RE Willamette Water Supply System Water Treatment Plant (WTP)
 Land Use Application Submittal – Supplement

Service Provider Letter

**Willamette Water Supply Program
 Water Treatment Plant (WWSP WTP)
 CWS Site Assessment**

Figure 2a
 Existing Conditions

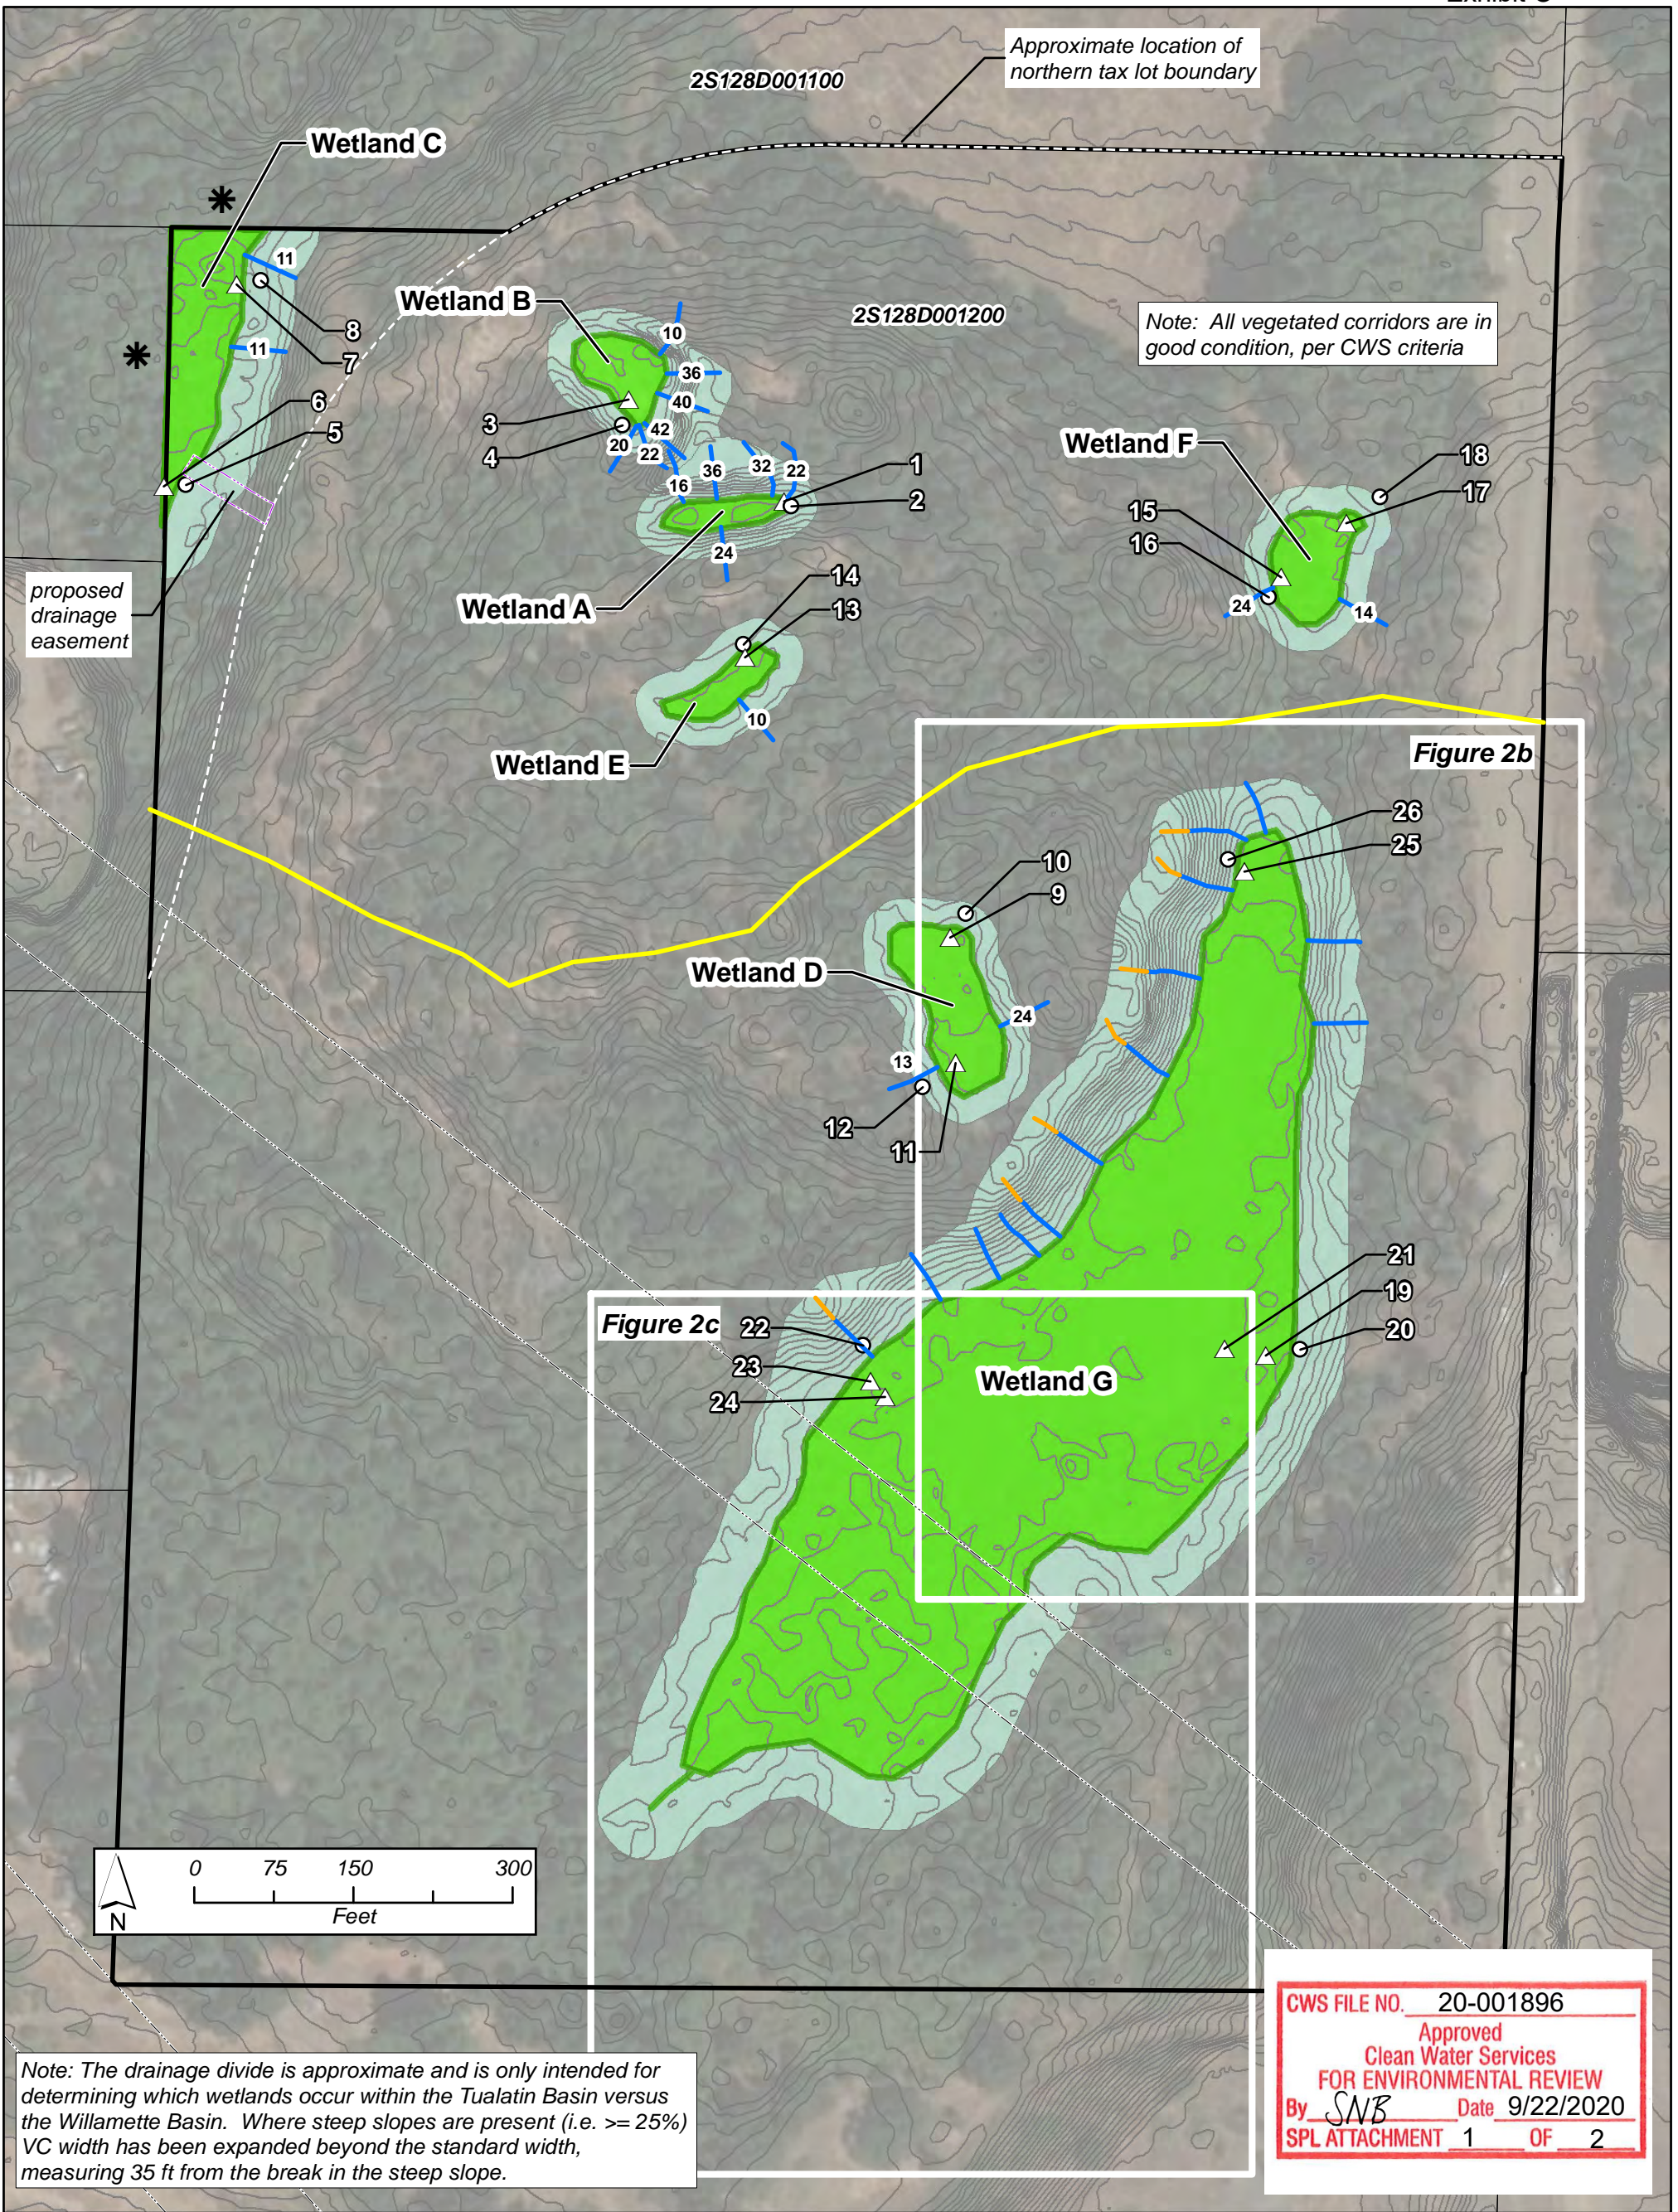
* Note: Permanent impacts have been permitted for the entirety of Wetlands A, B, D, E, and F. Therefore, no vegetated corridors (VC) will remain and per CWS rules, VC mitigation is not required for these features. VC mitigation for permanent impacts to the VC around Wetland G is proposed as noted on this figure.

Figure 3
 Proposed Development

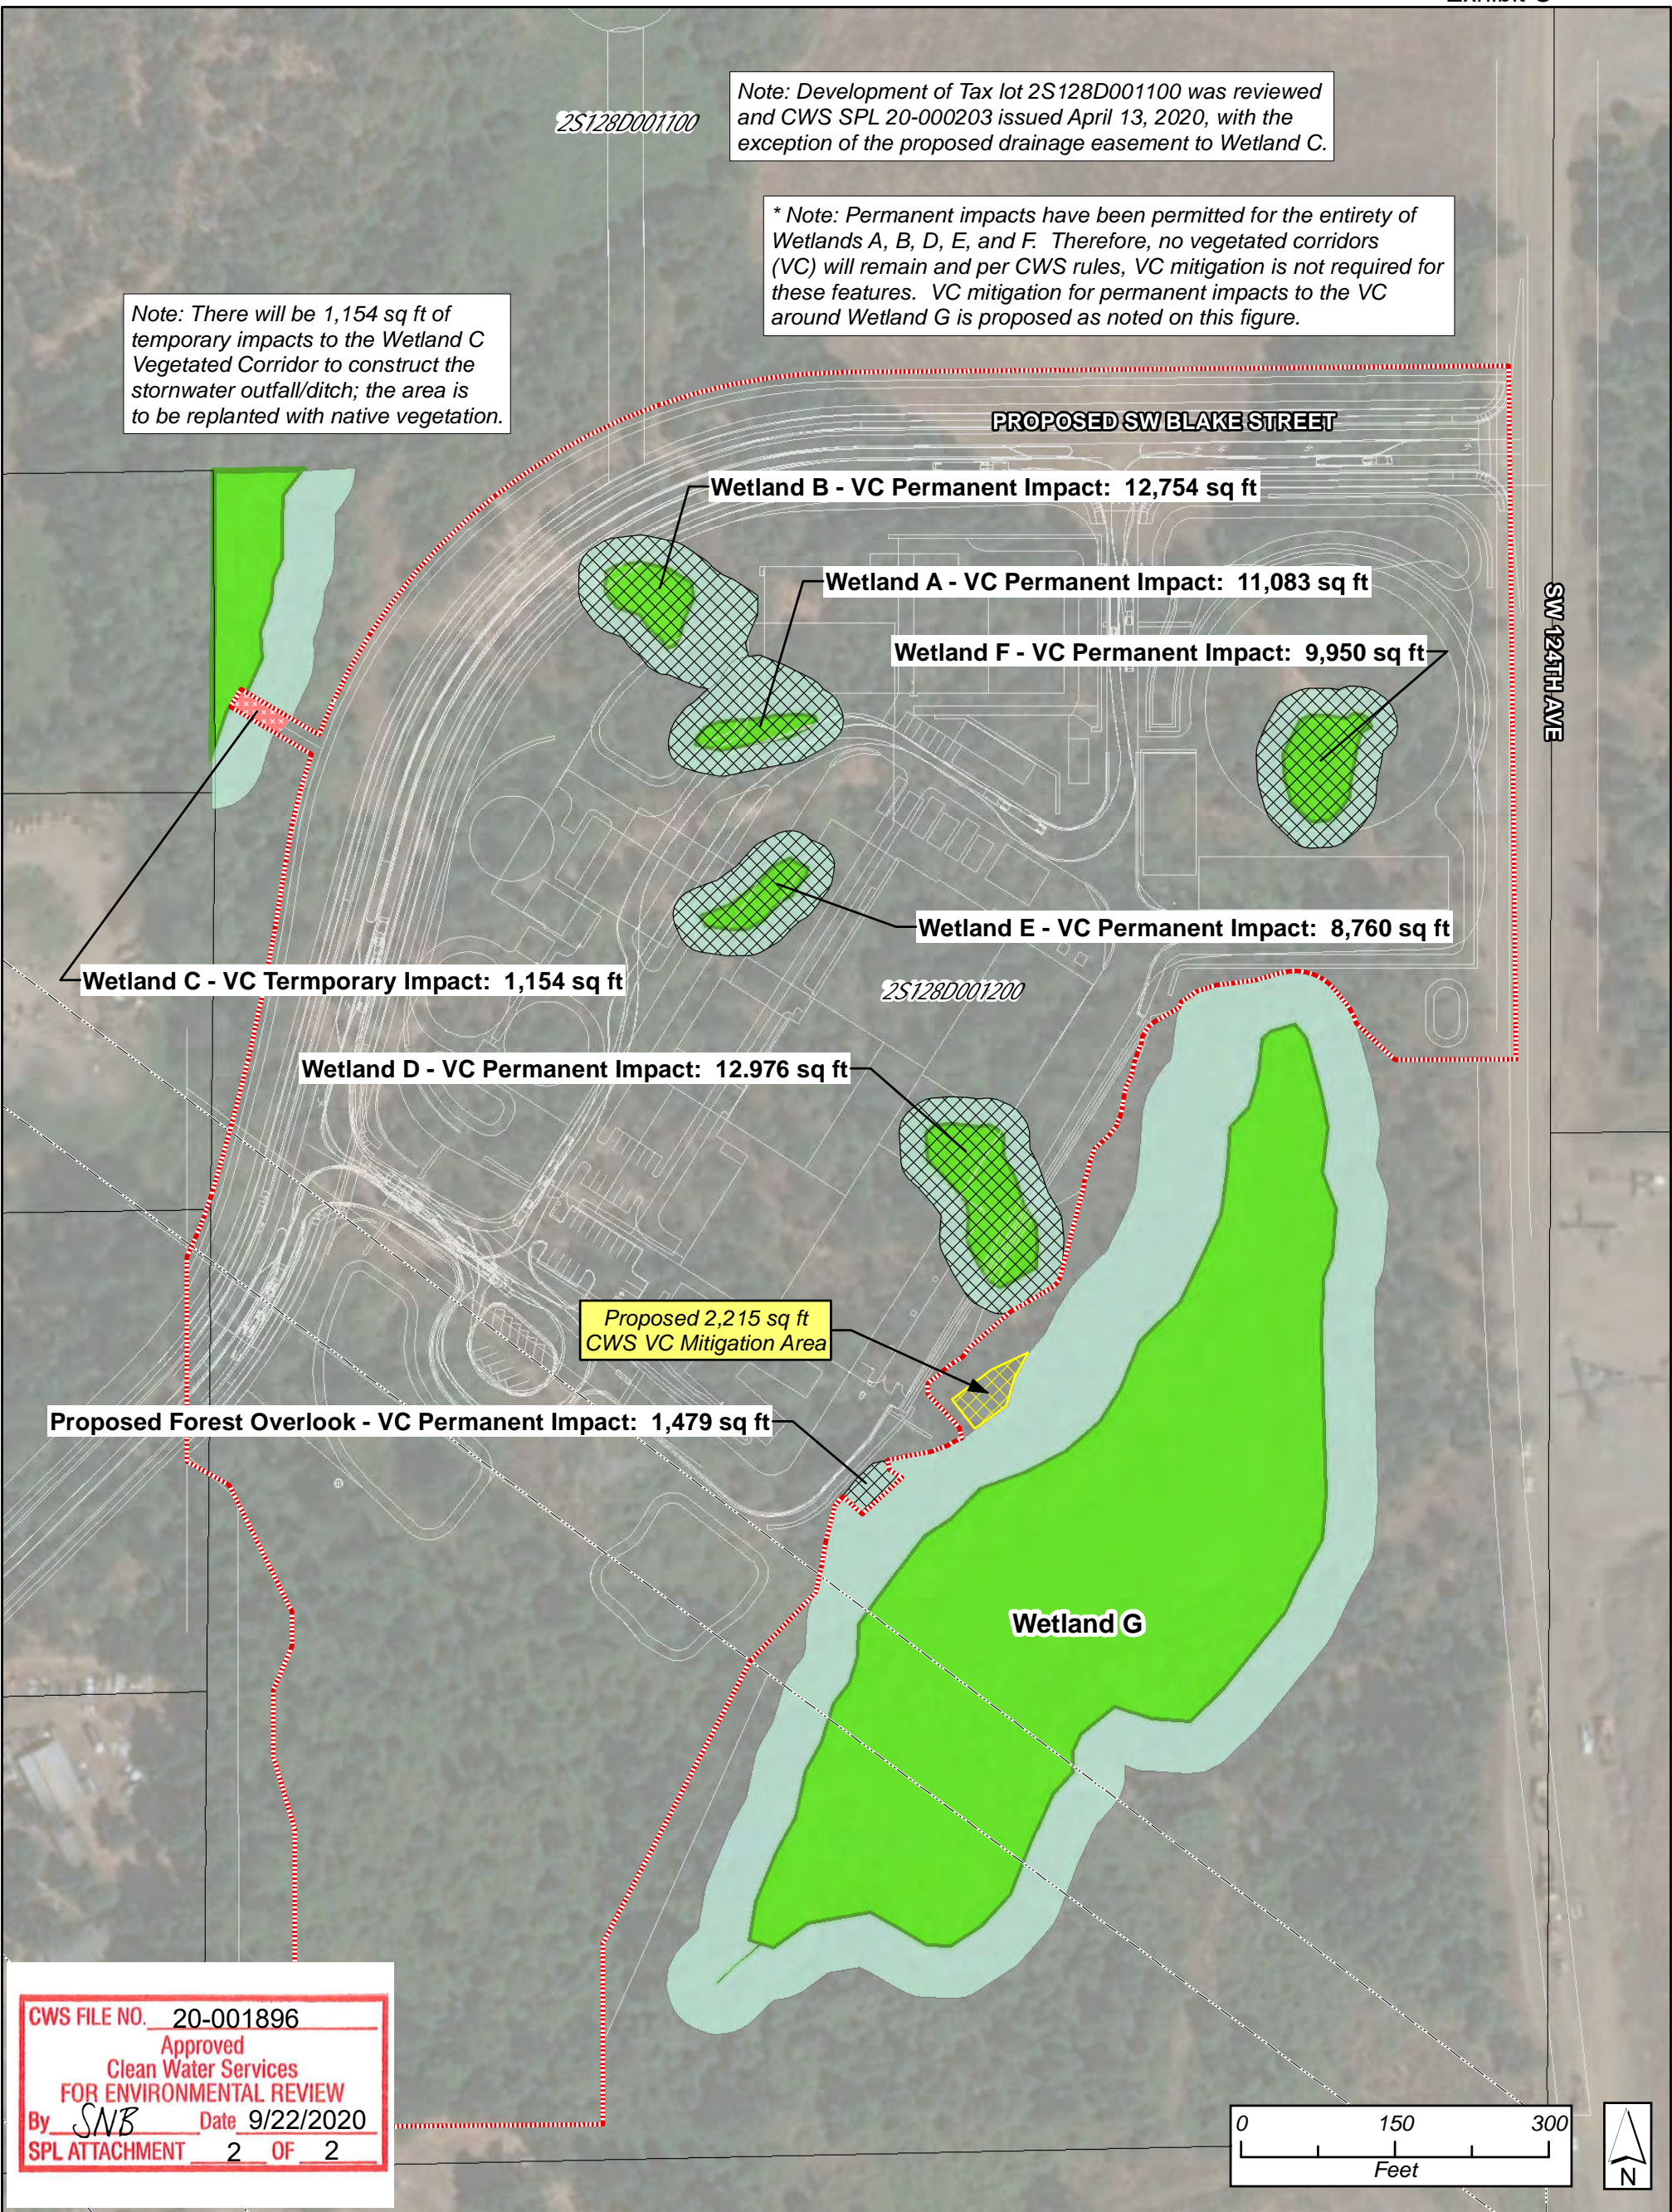
- Placement of the overlook further north along the VC edge. This alternative would have placed the overlook roughly in the area of the proposed mitigation shown in revised Figure 3. Although this would have mostly avoided the VC, it would have required impacts to several large oak trees and associated high quality habitat. In addition, placing the overlook further to the north would put it past the WTP security boundary and therefore would have put many more limitations on visitation by the public, with all visits requiring WTP staff escort. This was deemed impractical.

Note: There will be 1,154 sq ft of temporary impacts to the Wetland C Vegetated Corridor to construct the stormwater outfall/ditch; the area is to be replanted with native vegetation.
